**SUBJECT: RESPONSE TO THE NOTICE OF DISAPPROVAL FOR THE INVESTIGATION WORK PLAN FOR SOLID WASTE MANAGEMENT UNIT 21-017(a)-99, MATERIAL DISPOSAL AREA U, AT TECHNICAL AREA 21**

**Response to the "Notice of Disapproval for the Investigation Work Plan  
for Solid Waste Management Unit 21-017(a)-99,  
Material Disposal Area U, at Technical Area 21  
Los Alamos National Laboratory (LANL), EPA ID #NM0890010515 HWB-LANL-04-015"  
Dated January 28, 2005**

Figure 2.1-1. Material disposal areas in TA-21

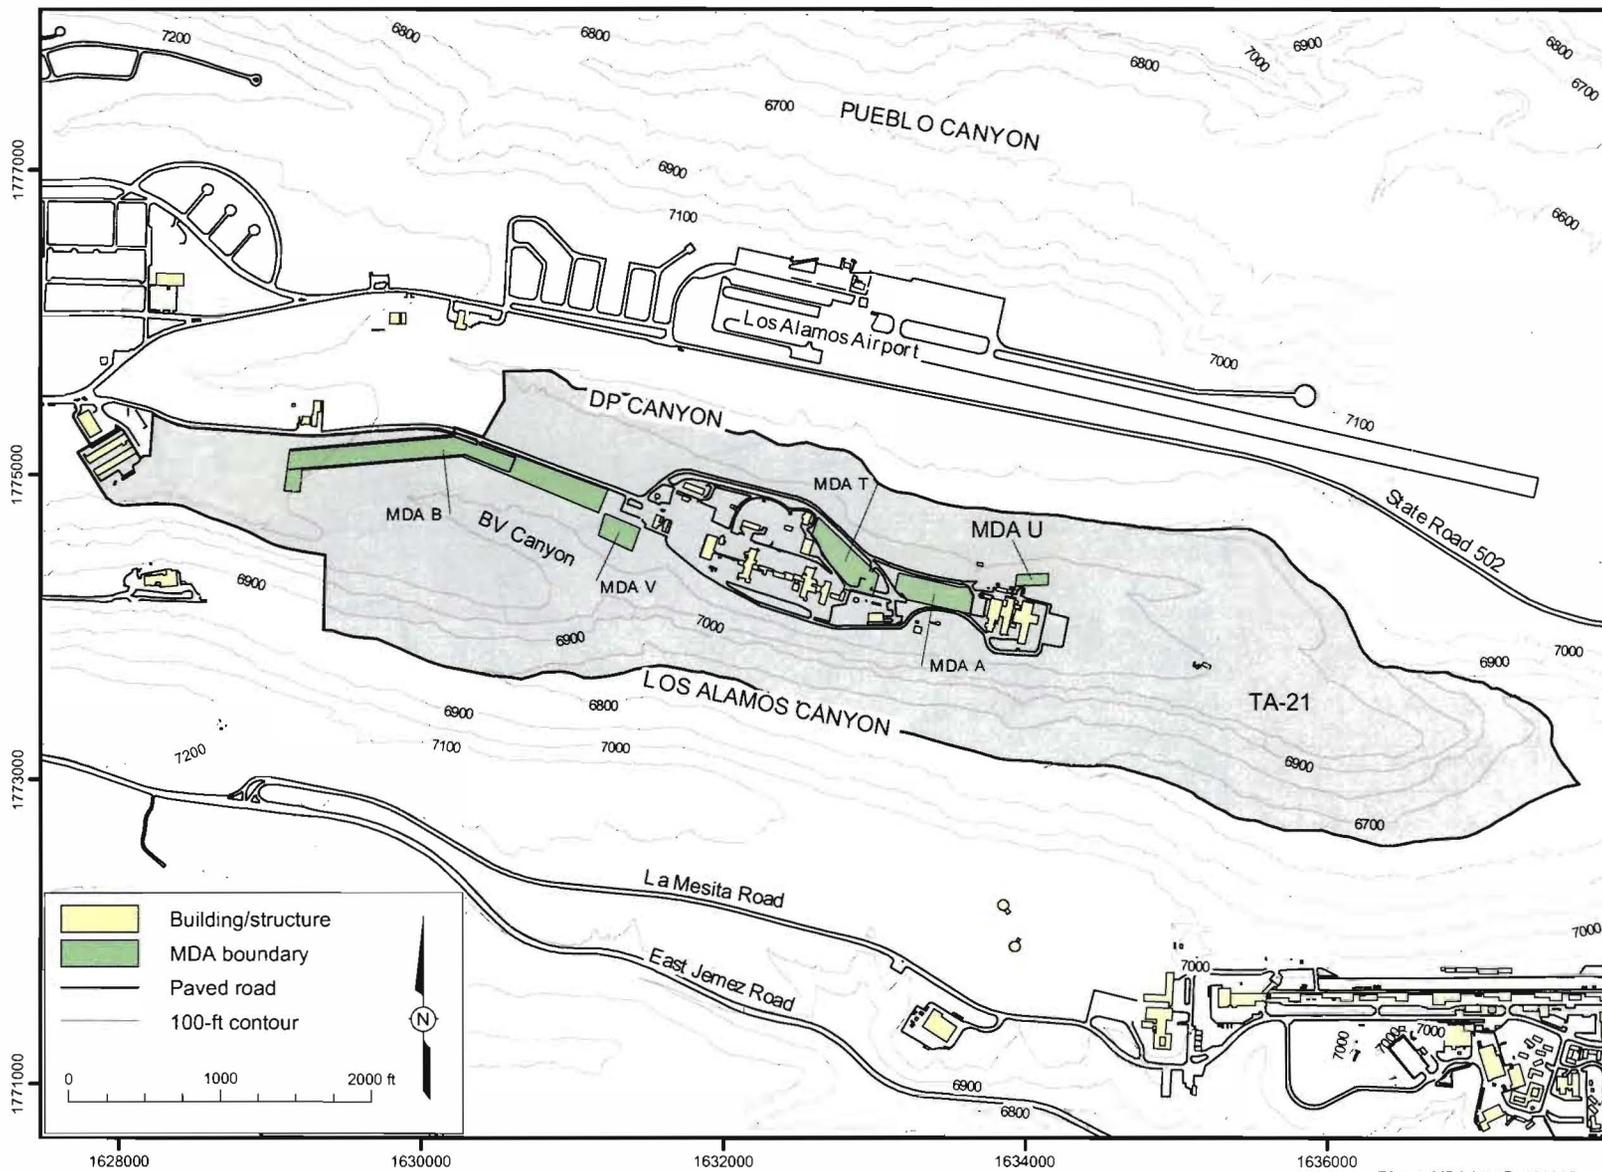
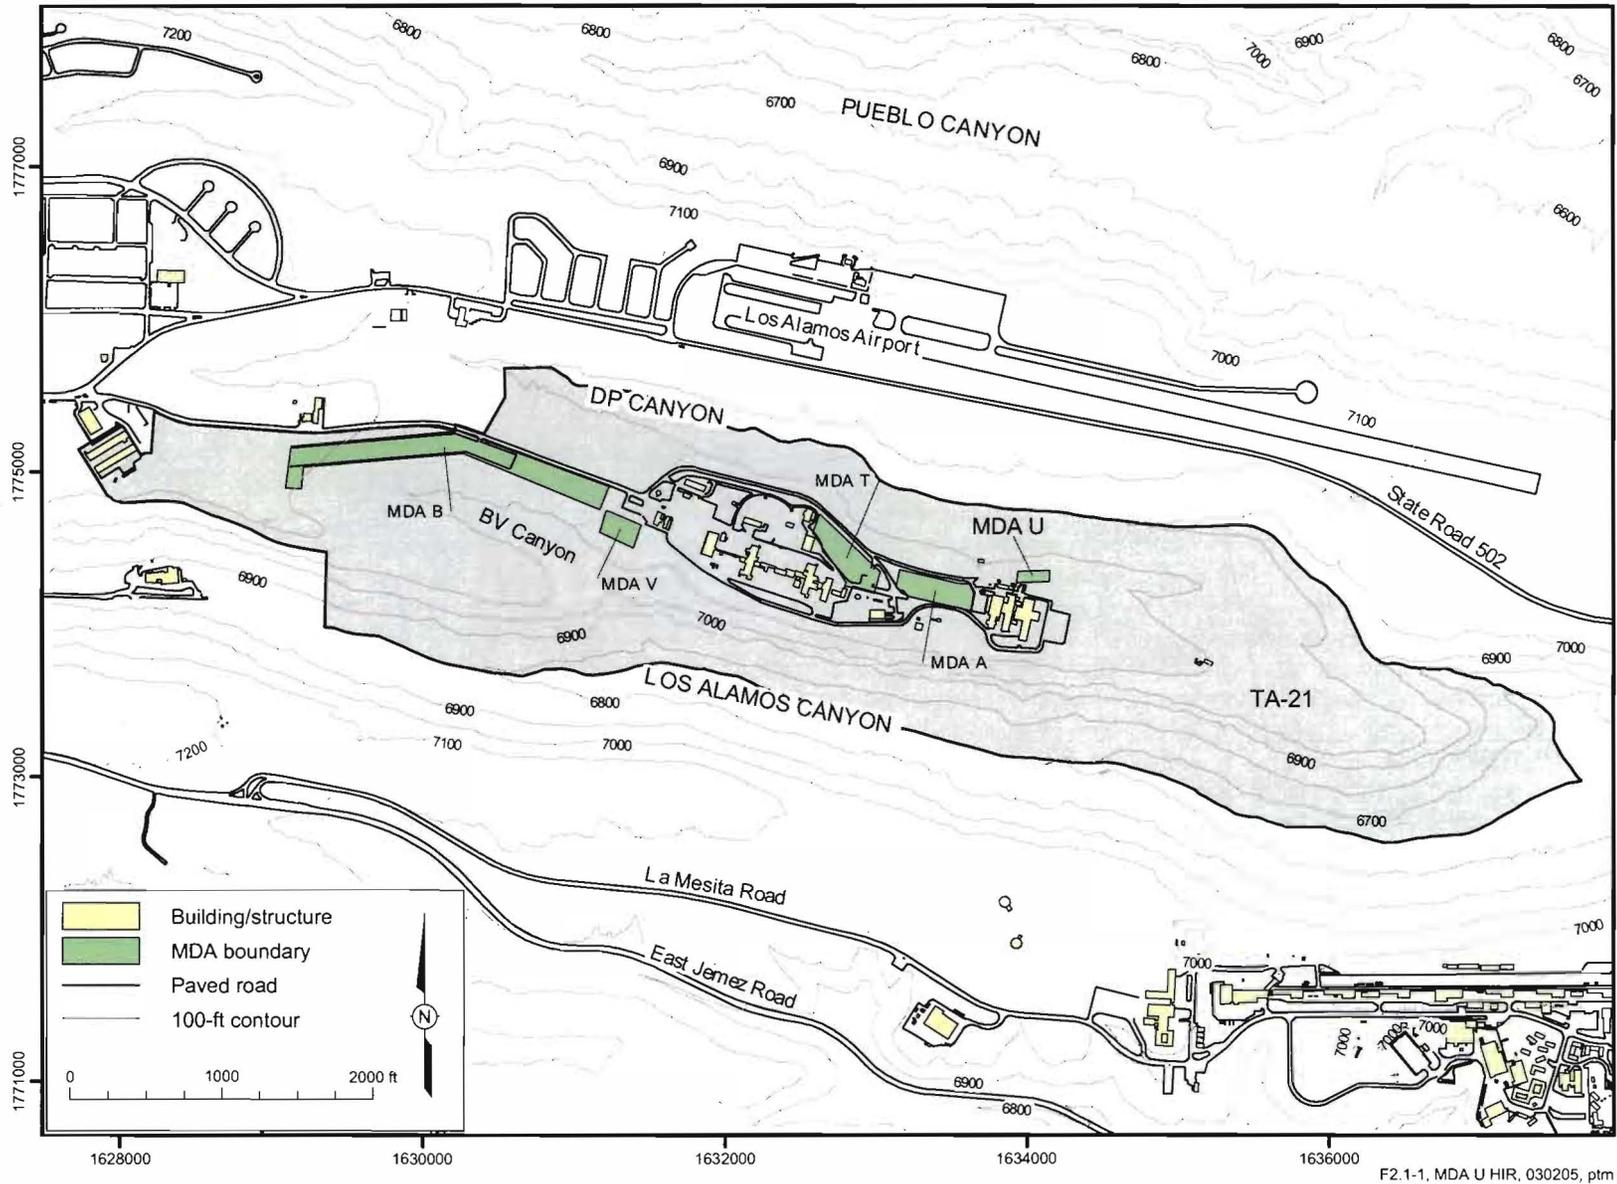
1. *Figure 2.1-1 in the Historical Investigation Report (HIR) is incorrectly labeled. All MDA boundaries should be in green and buildings/structures in yellow. The figure shows all MDAs in yellow except MDA V. The Permittees must ensure the legend corresponds to the figure.*

1. LANL has revised Figure 2.1-1 from the historical investigation report (HIR) for MDA U to ensure that the legend corresponds to the figure. Two replacement pages showing the revised figure are provided with this response.

Figure 2.1-2. Consolidated SWMU 21-017(a)-99

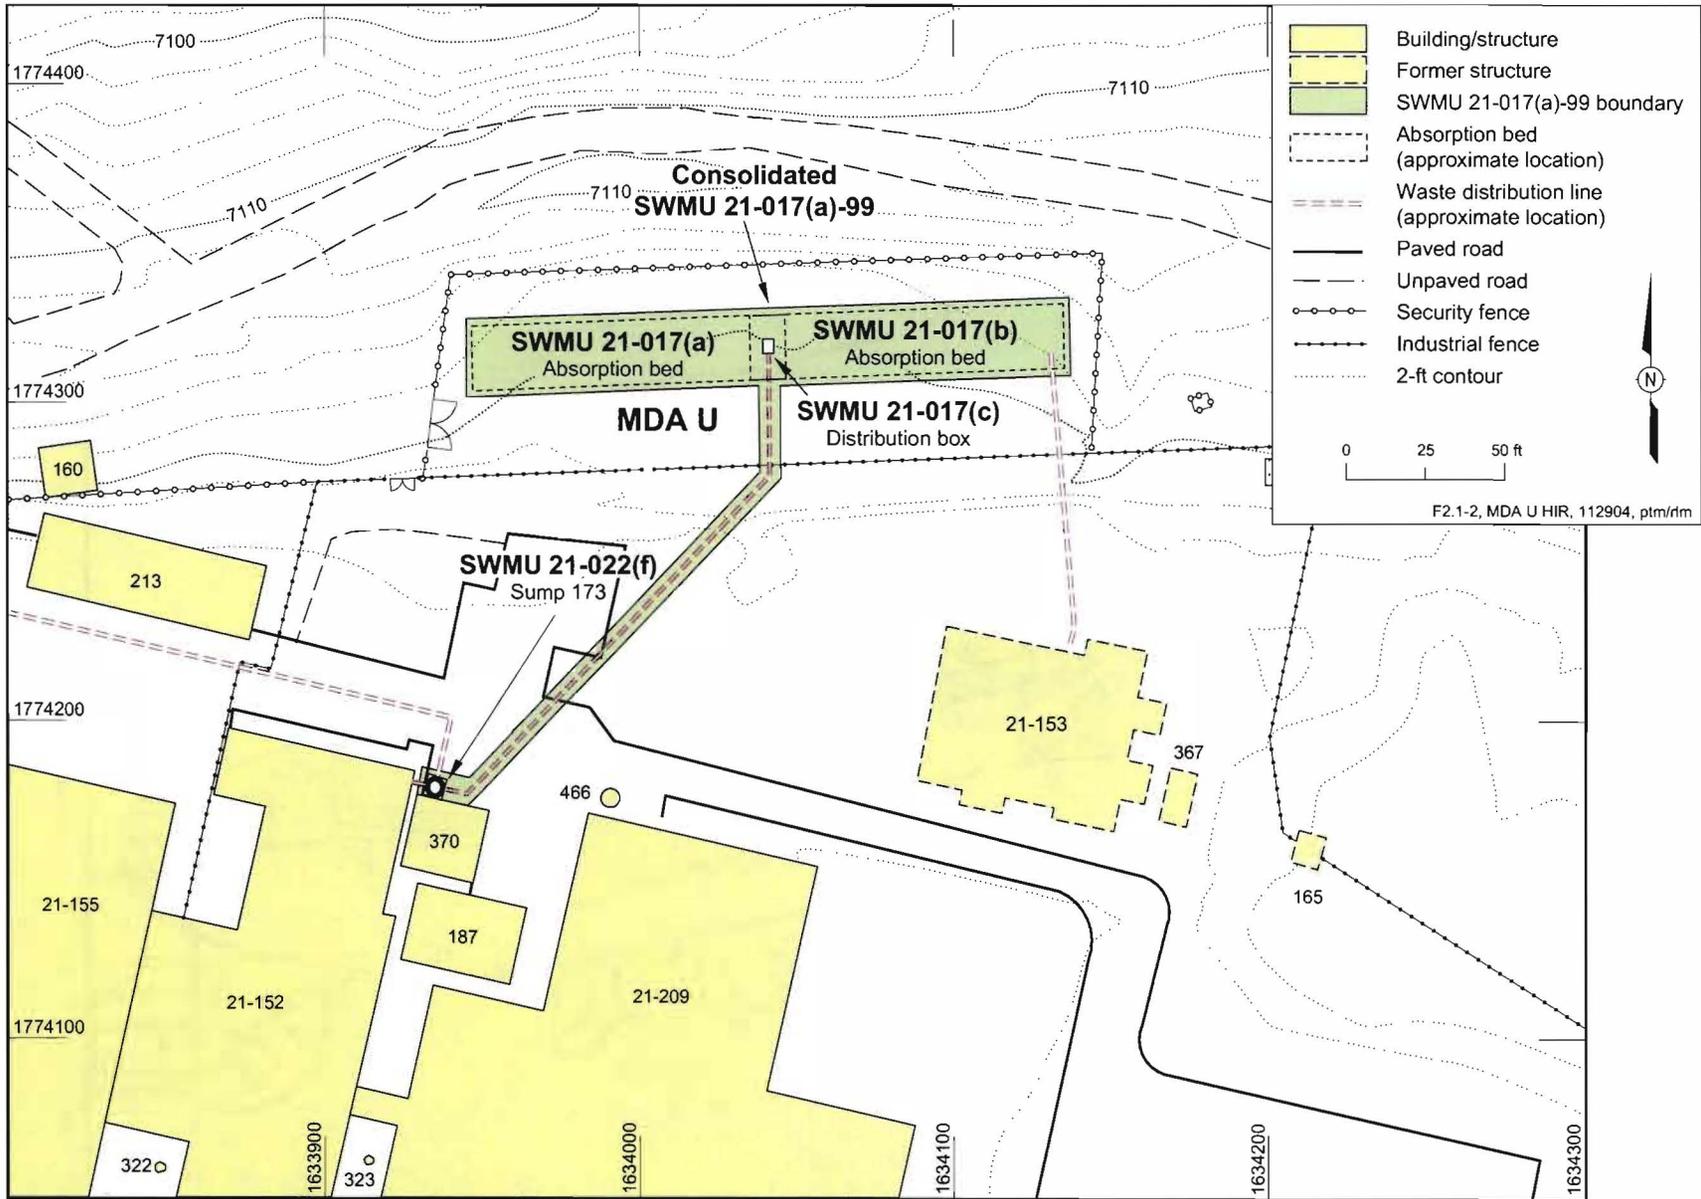
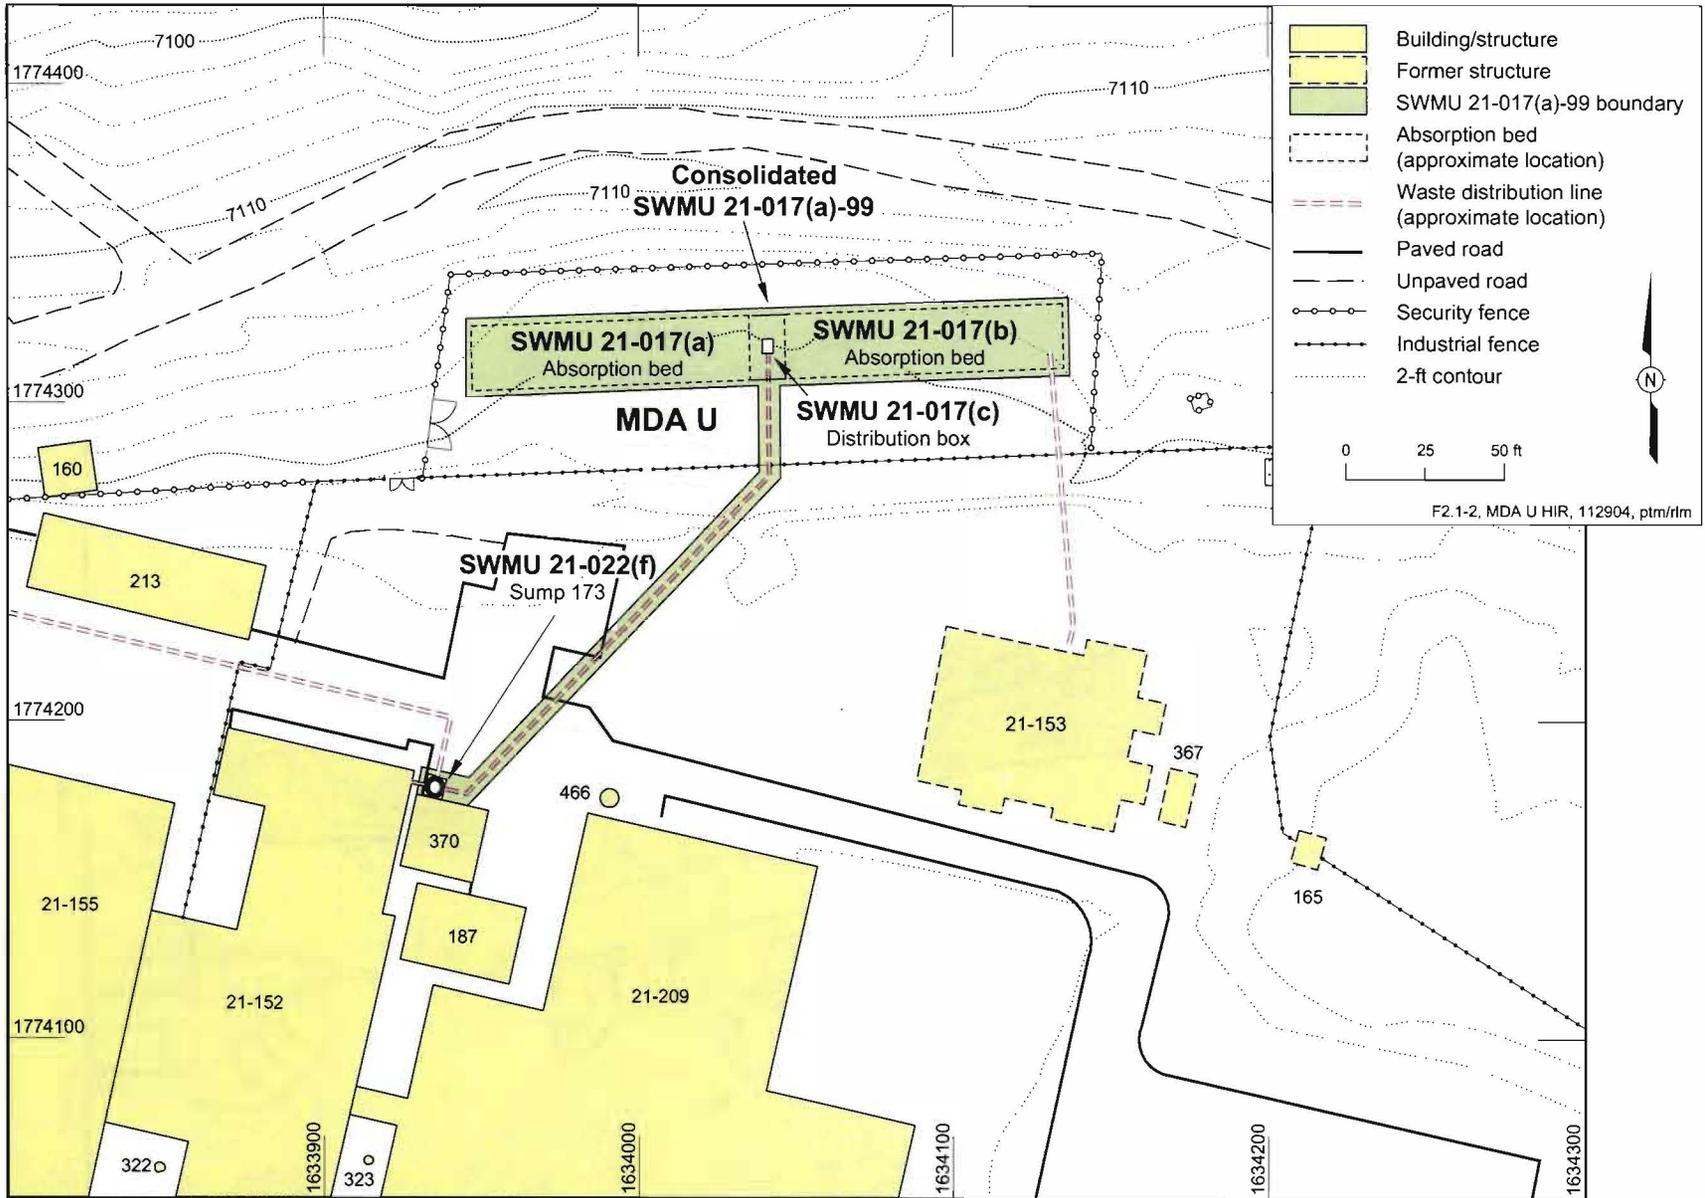
*Figure 2.1.2 does not show the distribution lines from all buildings that contributed waste to MDA U. The Permittees must include on a figure the location of the distribution line from the cooling tower at Building 21-155 to the MDA U western absorption bed and explain if the line is part of this investigation.*

Figure 2.1-2, as presented in the work plan, shows the best available information regarding the former location of the distribution line from the cooling tower associated with Building 21-155. This undocumented line, which ran into the west end of the western MDA U absorption bed, was discovered during the 1985 excavation activities. Although this former distribution line is not part of SWMU 21-017(a)-99 and is not specifically addressed in the investigation work plan for MDA U, borehole location 21-10838, drilled and sampled in 1998, falls in the immediate area of the former line (see work plan figure 4.2-1). This location had trace concentrations of tritium and organic chemicals in soil vapor at the total depth of 75 ft below ground surface (bgs). Metals, which are commonly associated with cooling tower effluent, were detected to a depth of 55 ft bgs at concentrations just above background values.
